**Section 16 Planning Application for Proposed Temporary Sales of Private Cars,
Motor Vehicle Showroom, Vehicle Maintenance Workshop,
Retail Shop for Car Components/ Accessories and Convenience Store
with Associated Uses for a Period of 3 Years
at Lot Nos. 766 S.A, 766 S.C and 767 in D.D. 115, Au Tau, Yuen Long**

(Application No. A/YL-NSW/370)

Further Information I

Revised Fire Services Installation Proposal

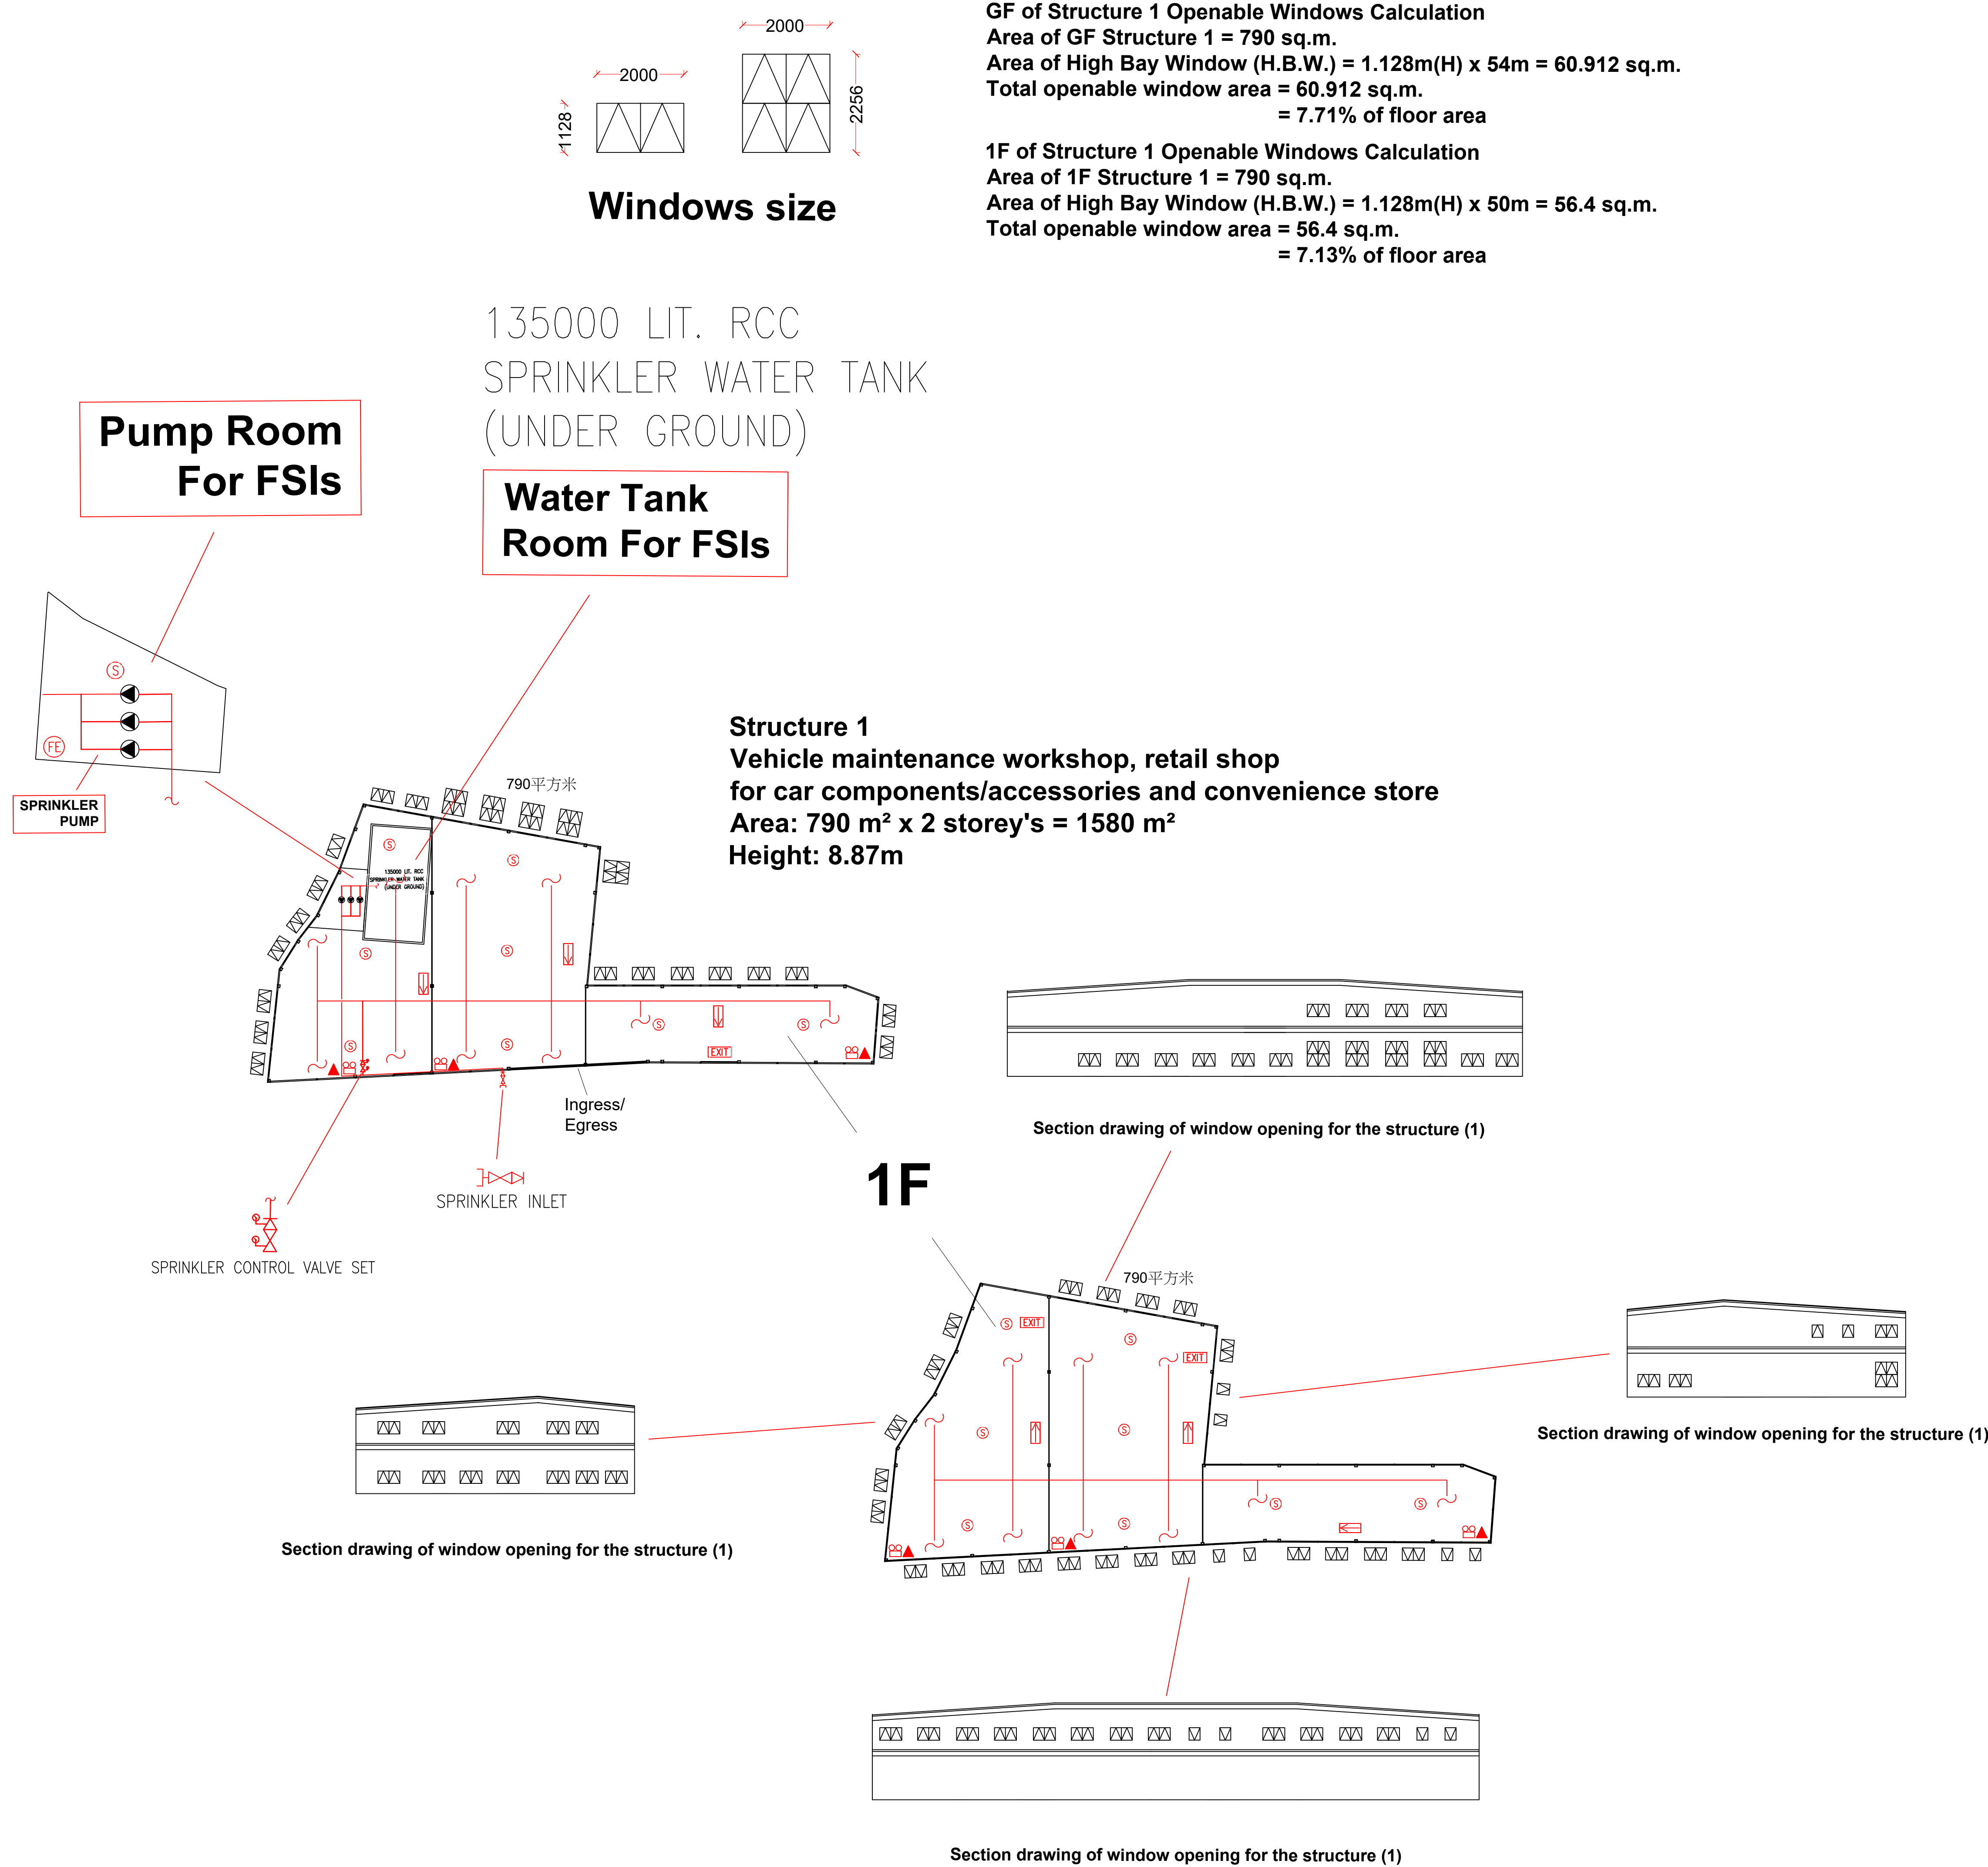
Item	Departmental Comments	The Applicant's Responses
FSD(1)	Based on the submitted FSI proposal, his comments are as follows: i. A sufficient number of directional & exit signs shall be provided; and ii. The sprinkler inlets shall be positioned in a prominent	Noted. Please find attached revised Fire Services Installation Proposal (see Appendix I) for your attention.

Drainage Proposal for

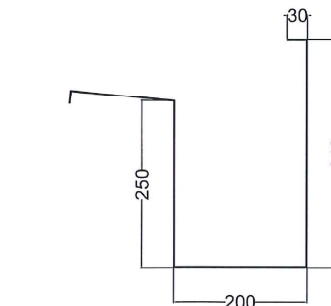
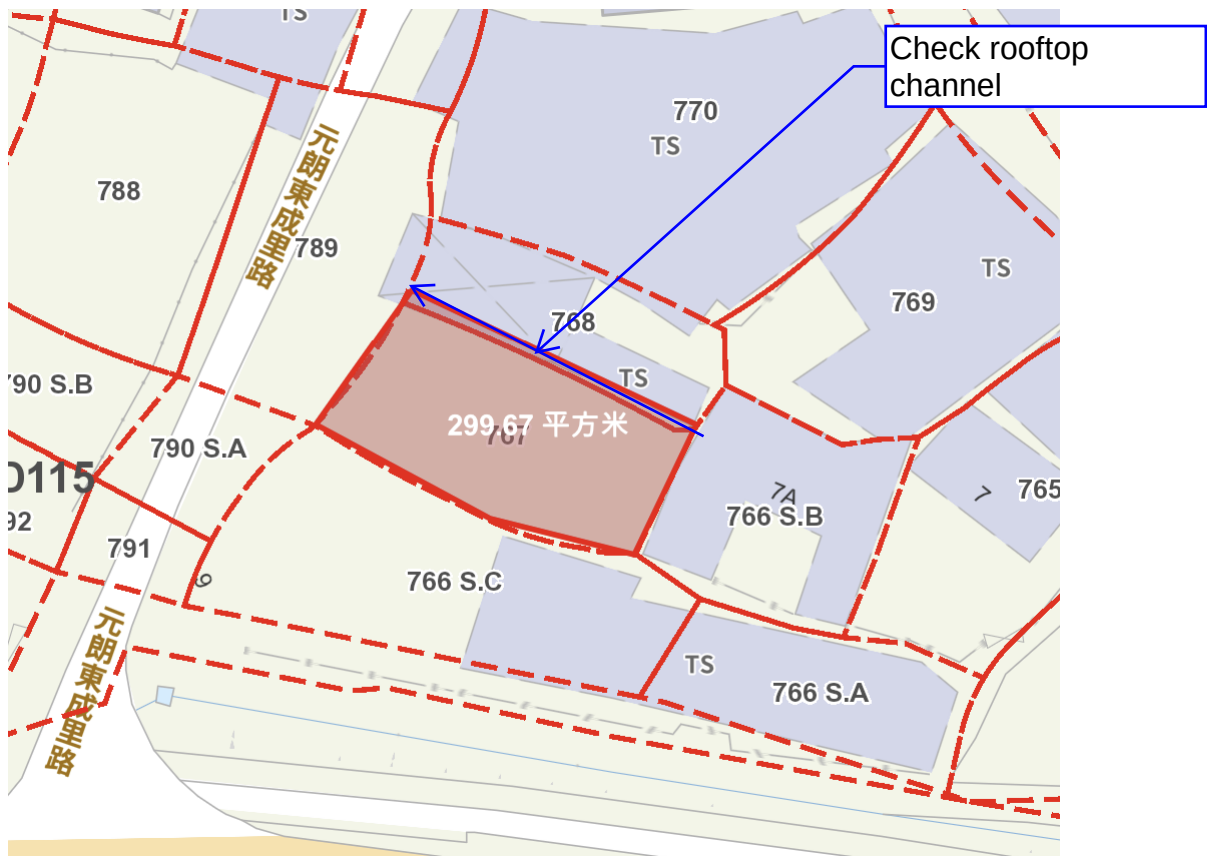
Item	Departmental Comments	The Applicant's Responses
DSD(1)	Based on the submitted Drainage proposal, his comments are as follows: It should be noted that the current drainage proposal still requires refinement to meet the necessary requirements. To encourage a higher quality submission and avoid rounds of comments, thereby shortening the processing time, the applicant is advised to complete the attached checklist (Appendix A) as part of preparing the revised proposal and include them in the submission. Otherwise, a longer processing time may be required by this office.	Noted. Please find attached revised Drainage Proposal (see Appendix II) for your attention.
